SUBJECT: UNIT 1 CYCLE 10 TECHNICAL SPECIFICATION AMENDMENT (TAC 67143)

CALVERT CLIFFS NUCLEAR POWER PLANT, UNIT 1

Amendment No. 130
License No. DPR-53

SAFETY EVALUATION BY THE OFFICE OF NUCLEAR REACTOR REGULATION
RELATED TO AMENDMENT NO. 130 TO FACILITY OPERATING LICENSE NO. DPR-53
BALTIMORE GAS AND ELECTRIC COMPANY
CALVERT CLIFFS NUCLEAR POWER PLANT, UNIT 1
DOCKET NO. 50-317

Figure 2.2-1
Peripheral Axial Shape Index, Y_I vs Fraction of Rated Thermal Power

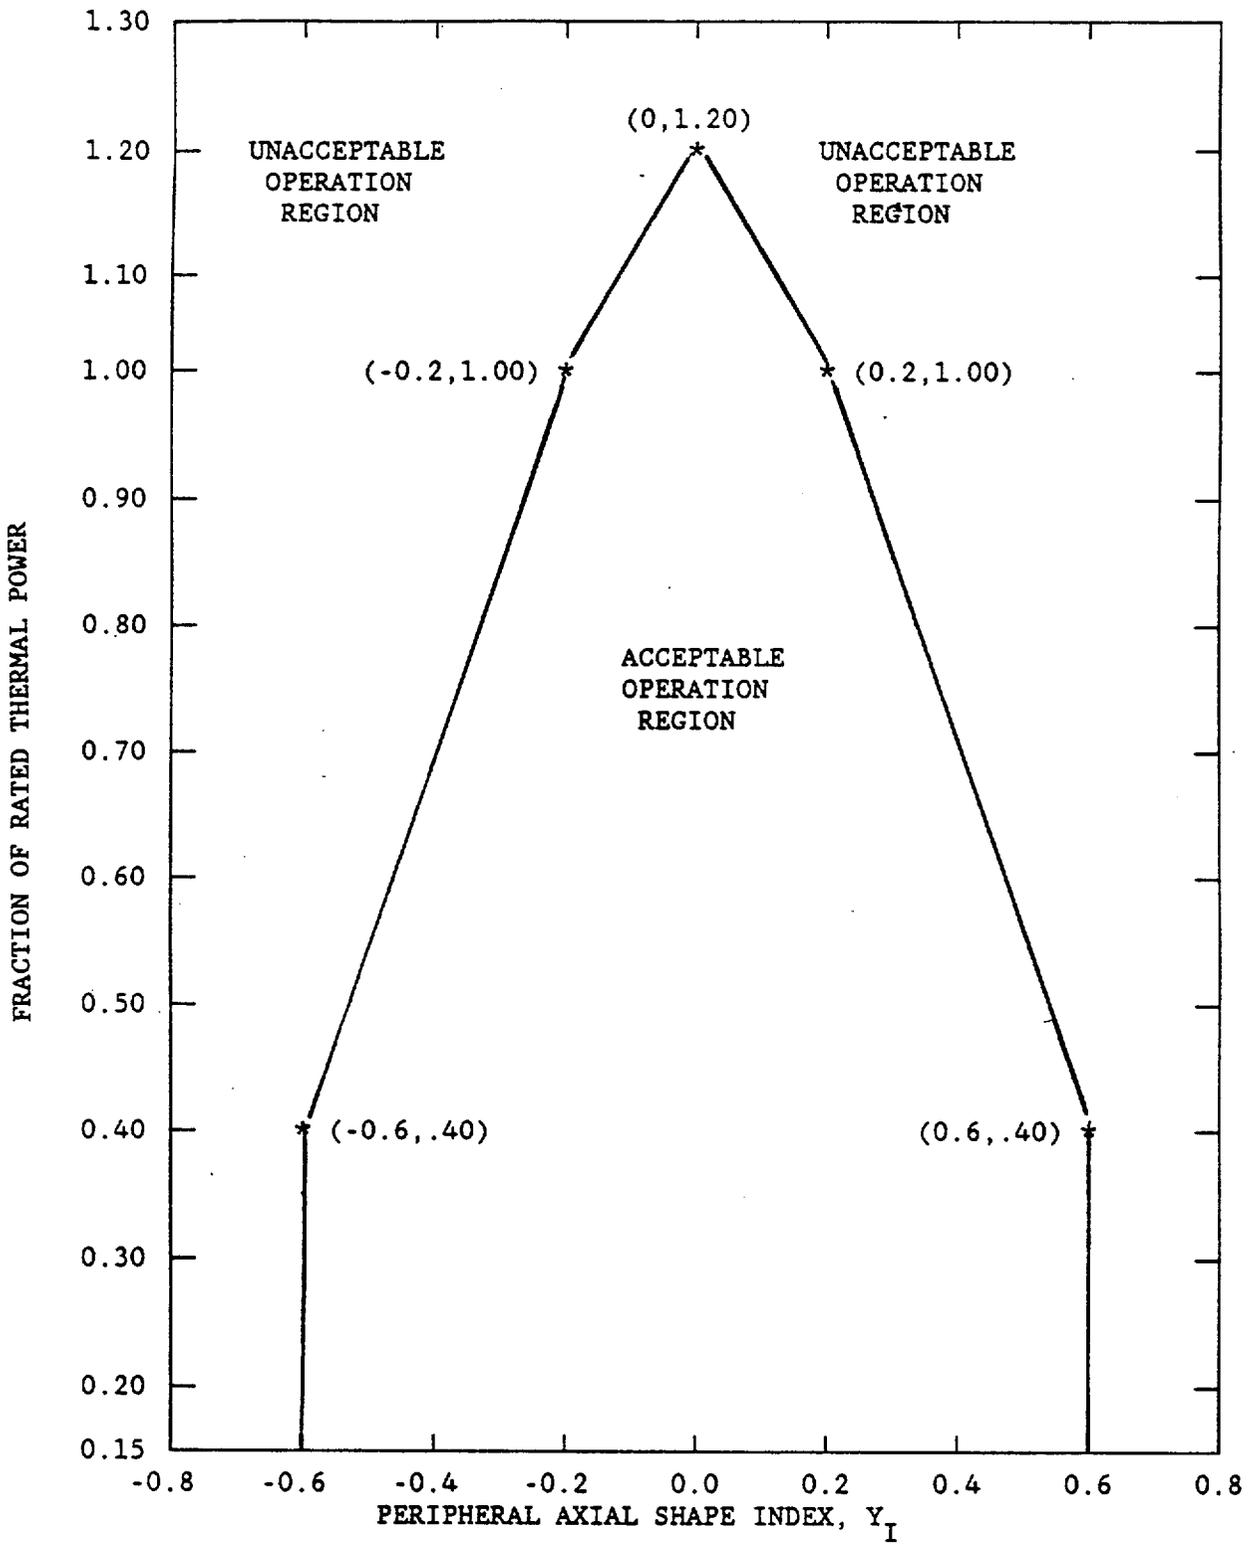
4. Reduce unnecessary Axial Shape Index (ASI) trips below 70% RTP and provide additional operation flexibility by:
 - a. modifying TS Figure 2.2-1, "Peripheral Axial Shape Index vs. Fraction of Rated Thermal Power," by increasing the acceptable operation region below 70% RTP to the area bounded by the linear equations for the ASI limits, where:

- (1) ASI limit = $\pm[.6 + 2/3 (.4-P)]$ (P is the fraction of RTP) between 40% and 100% RTP, and
- (2) ASI limit = ± 0.6 at powers below 40% RTP.

The current ASI limits are ± 0.4 at power below 70% RTP;

6.7 Figure 2.2-1 Axial Power Distribution Trip LSSS

Figure 2.2-1 is modified to increase the positive and negative axial shape index (ASI) regions below 70% power. The setpoint analysis uses the modified results given by Figure 2.2-1 and the licensee has determined that acceptable results are obtained for Unit 1 Cycle 10 and Unit 2 Cycle 8. The changes to Figure 2.2-1 are, therefore, acceptable for both units.

FIGURE 2.2-2

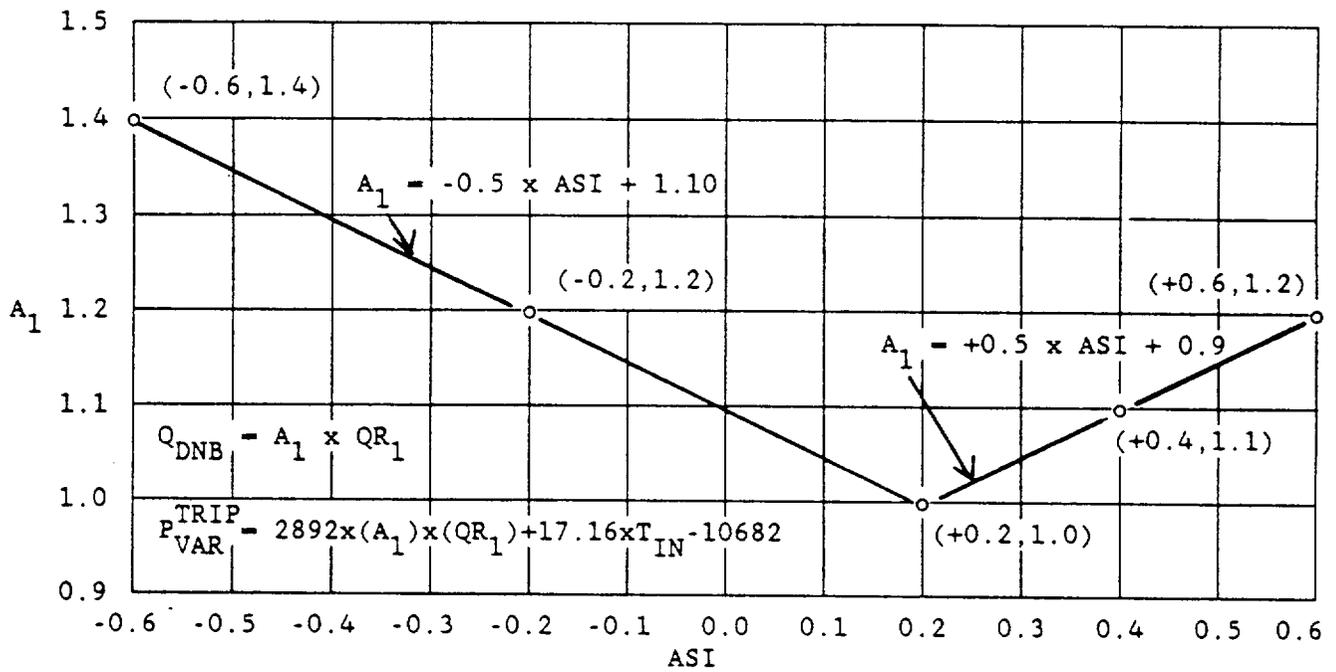
- 5. Reflect the lowering of the departure from nucleate boiling ratio (DNBR) limit to 1.15 due to the incorporation of an extended statistical combination of uncertainties methodology through modifying Figures 2.2-2, "Thermal Margin/Low Pressure Trip Setpoint Part 1 (ASI v. A_1)," and 2.2-3, "Thermal Margin/Low Pressure Trip Setpoint Part 2 (Fraction of Rated Thermal Power v. QR_1)," by

6.1 Figure 2.2-2 Thermal Margin/Low Pressure Trip Setpoint-Part 1

Figure 2.2-2 is modified due to a revision in the curve fit for the TM/LP trip setpoint to accommodate the implementation of the extended statistical combination of uncertainties methodology. The setpoint analysis uses this methodology and the licensee has determined that acceptable results are obtained for Cycle 10. The changes to Figure 2.2-2 are, therefore, acceptable.

FIGURE 2.2-3

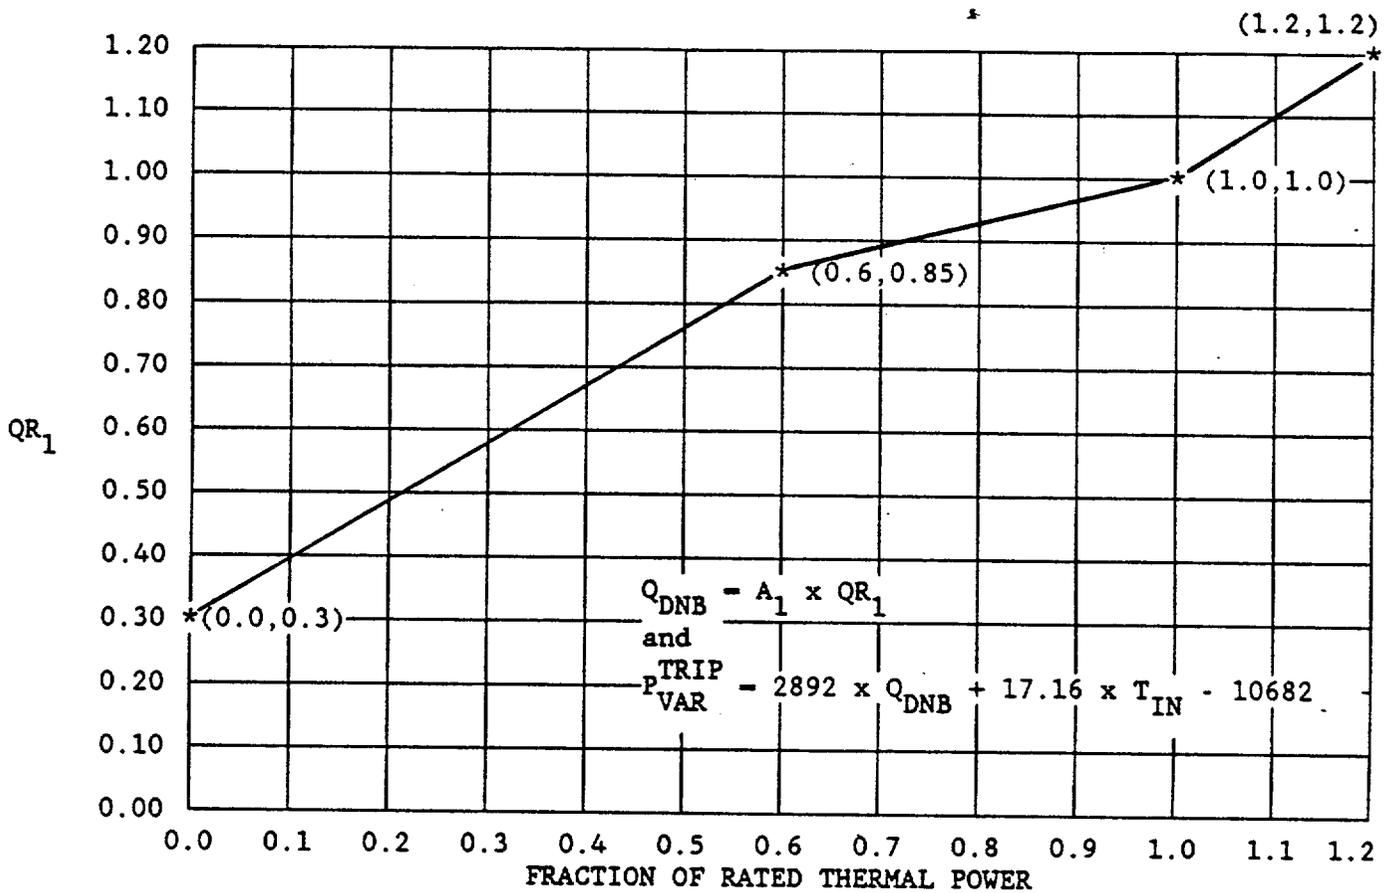
- a. changing the equation for the pressure variable trip from
 - $P \text{ (TRIP VAR)} = 2061 (Q_{DNB}) + 15.85 (T_{IN}) - 8915$ to
 - $P \text{ (TRIP VAR)} = 2892 Q_{DNB} + 17.16 (T_{IN}) - 10682$;

- b. changing Q_{DNB} , which equals $QR_1 \times A_1$, by increasing QR_1 from the values of:

$$QR_1 = .3 + (11/12)P \text{ between } 0\% \text{ and } 60\% \text{ RTP}$$

$$QR_1 = .85 + (3/8) \times (P - .6) \text{ between } 60\% \text{ and } 100\% \text{ RTP}$$

$$QR_1 = P \text{ above } 100\% \text{ RTP}$$

6.2 Figure 2.2-3 Thermal Margin/Low Pressure Trip Setpoint-Part 2

Figure 2.2-3 is modified for the same reason as Figure 2.2-2 and the change is acceptable for the same reason.

Figure 3.1-1b

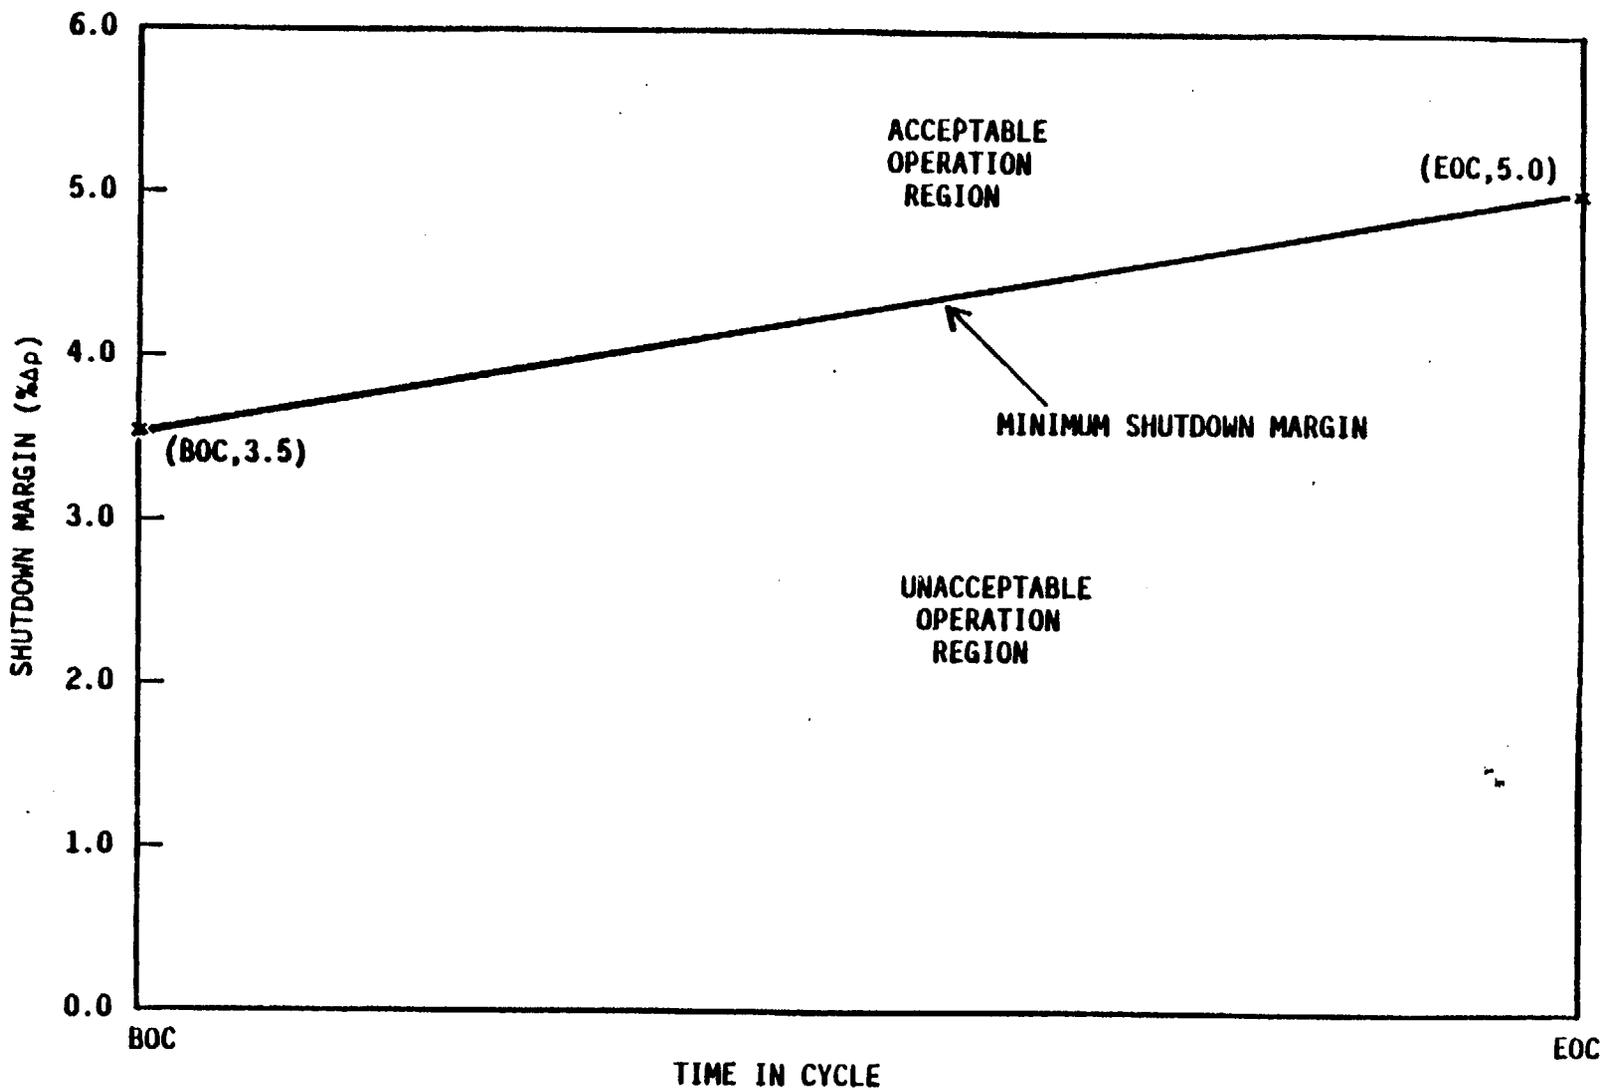
2. Increase the minimum required shutdown margin of TS LCO 3.1.1.1 above the currently required $+3.5 \Delta \text{ k/k}$ in accordance with the linear progression where the shutdown margin limit shall be greater than or equal to $+[3.5 + 1.5(P)] \Delta \text{ k/k}$ where P is the fraction of core cycle life. Thus at beginning of cycle, the shutdown margin limit is $+3.5 \Delta \text{ k/k}$ but at end of cycle the limit is $+5.0 \Delta \text{ k/k}$.

Two modifications are proposed for this TS. First, the shutdown margin is changed from a constant value to text which refers to a new Figure 3.1-1b which presents shutdown margin as a function of time in cycle. Since the required shutdown margin varies throughout the cycle due to fuel depletion, boron concentration and moderator temperature and this variation with cycle time has been incorporated in all the appropriate safety analyses for Cycle 10, this change is acceptable.

The shutdown margin at EOC is increased from 3.5% delta k/k to 5.0% delta k/k. The analysis of the Cycle 10 steam line rupture analysis, which is limiting at hot zero power EOC conditions, supports this change and it is, therefore, acceptable.

FIGURE 3.1-1a

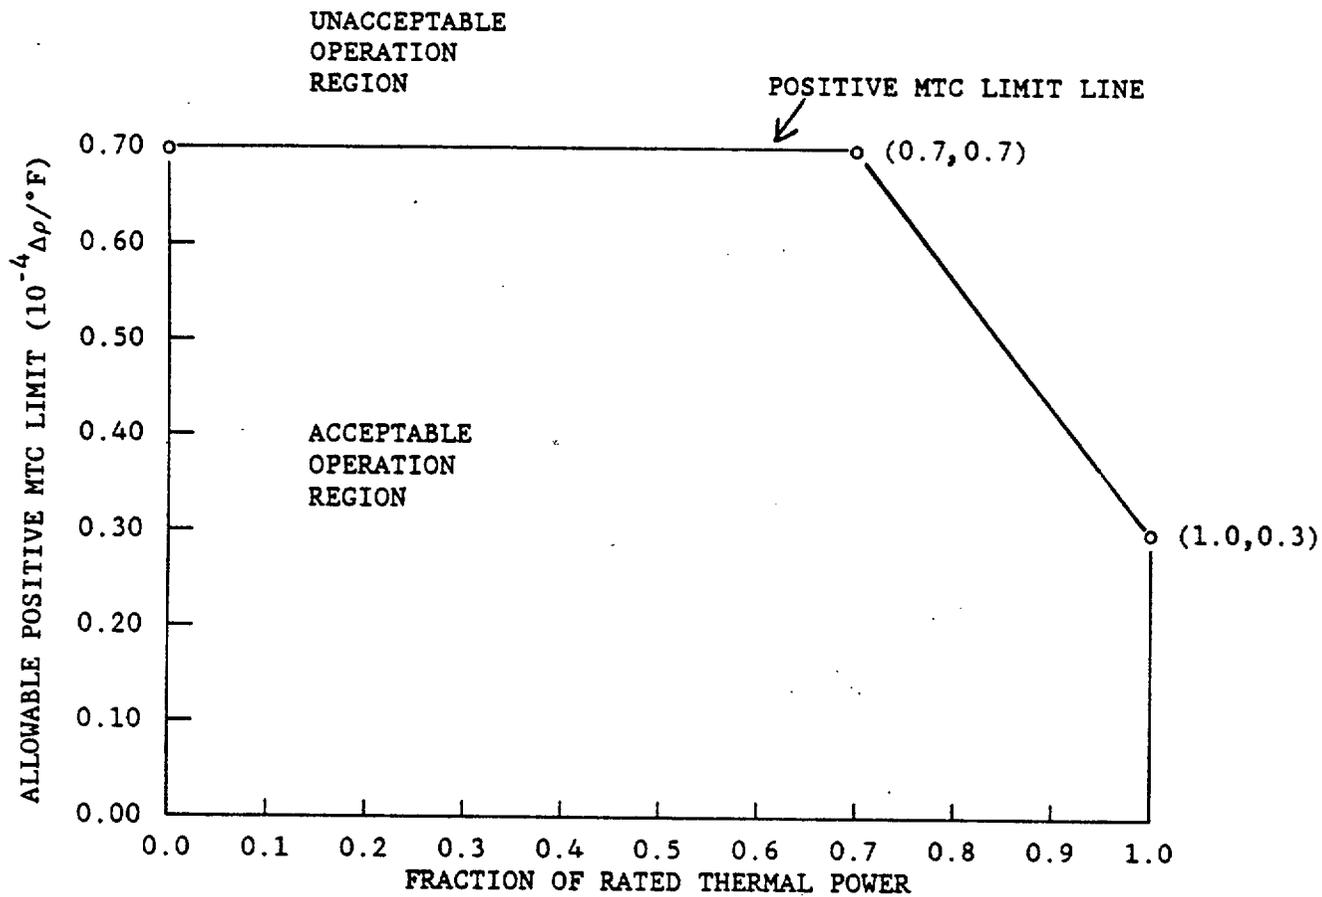
1. Modify Technical Specification (TS) Limiting Condition for Operation (LCO) 3.1.1.4 by adding a figure that provides the upper limits for moderator temperature coefficient (MTC) and increases this MTC limit for thermal power levels above 70% rated thermal power (RTP) from less positive than $0.2 \text{ E-4 } \Delta \text{ k/k/}^\circ\text{F}$ to the linear equation where the MTC limit is less positive than $+[(.9 + 4 (1-P)) / 3] \text{ E-4 } \Delta \text{ k/k/}^\circ\text{F}$ where P is the fraction of RTP. Thus at 70% RTP, MTC must be less positive than $+0.7 \text{ E-4 } \Delta \text{ k/k/}^\circ\text{F}$ and at 100% RTP MTC must be less positive than $+0.3 \text{ E-4 } \Delta \text{ k/k/}^\circ\text{F}$.

The MTC limit above 70% power is being raised from $+0.2 \times 10^{-4}$ delta rho/° F to a value which varies linearly from $+0.3 \times 10^{-4}$ delta rho/° F at 100% power to $+0.7 \times 10^{-4}$ delta rho/° F at 70% power. This change is being implemented to accommodate 24 month cycles and to facilitate initial reactor startup at the beginning of the cycle. The licensee has committed to a negative MTC at hot full power, equilibrium xenon conditions. As mentioned in Section 3.3, this value has been predicted to be -0.2×10^{-4} delta rho/° F. The feedline break analysis which supports this change is applicable to Cycle 10 and, therefore, the proposed change is acceptable.

Figure 3.1-2
 CEA GROUP INSERTION LIMITS VS. FRACTION OF ALLOWABLE THERMAL POWER
 FOR EXISTING RCP COMBINATION

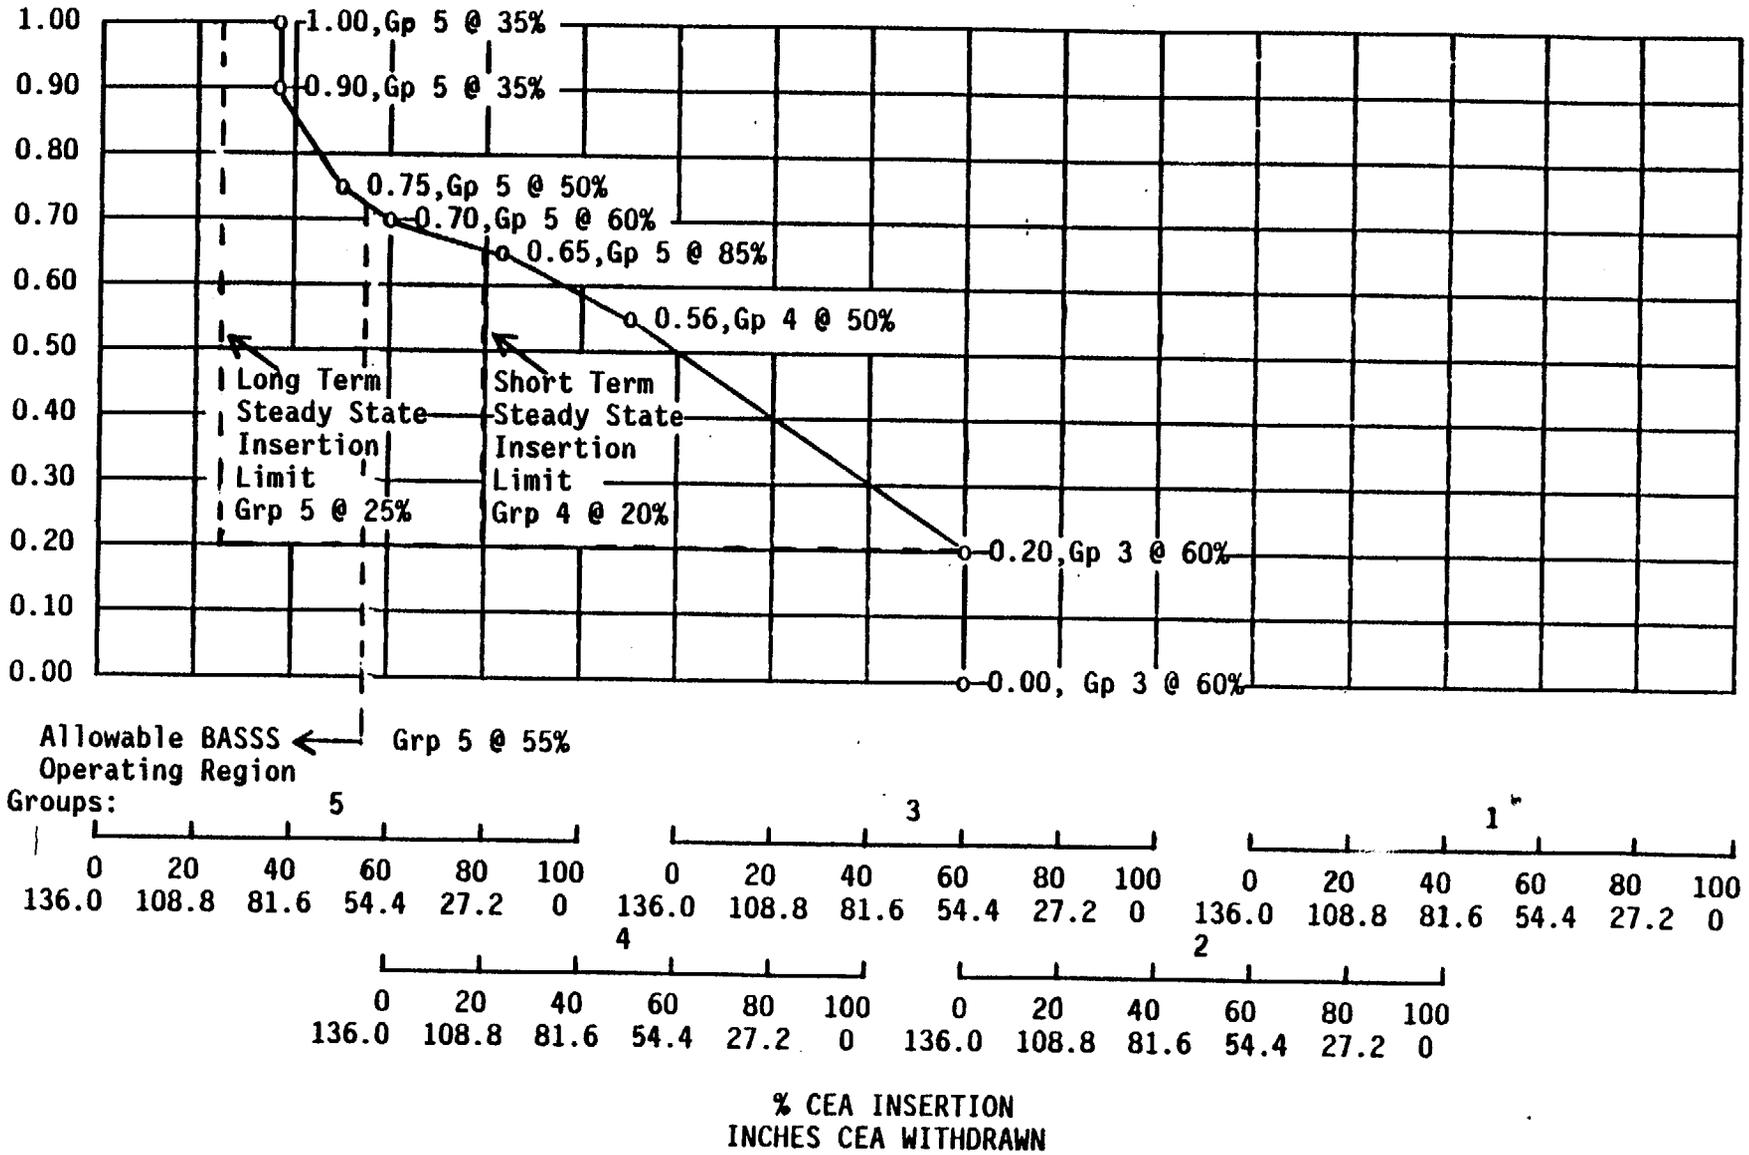
3. Change the TS Figure 3.1-2, "CEA Group Insertion Limits vs. Fraction of Allowable Thermal Power for Existing RCP Combination," Bank 5 Transient Insertion Limit from the linear progression with values of 25% insertion at 90% RTP and 35% insertion at 100% RTP to a constant insertion limit of 35% between 90% and 100% RTP.

6.6 Figure 3.1-2 CEA Group Insertion Limits

The transient insertion limit between 90% and 100% power is being increased from an allowed insertion limit which varies linearly from 35% for Bank 5 at 90% power to 25% at 100% power, to a constant value of 35%. This change, which is being made to enhance the ability to control axial oscillations near EOC, has been incorporated into all of the Cycle 10 physics, safety and setpoint analyses and is, therefore, acceptable.
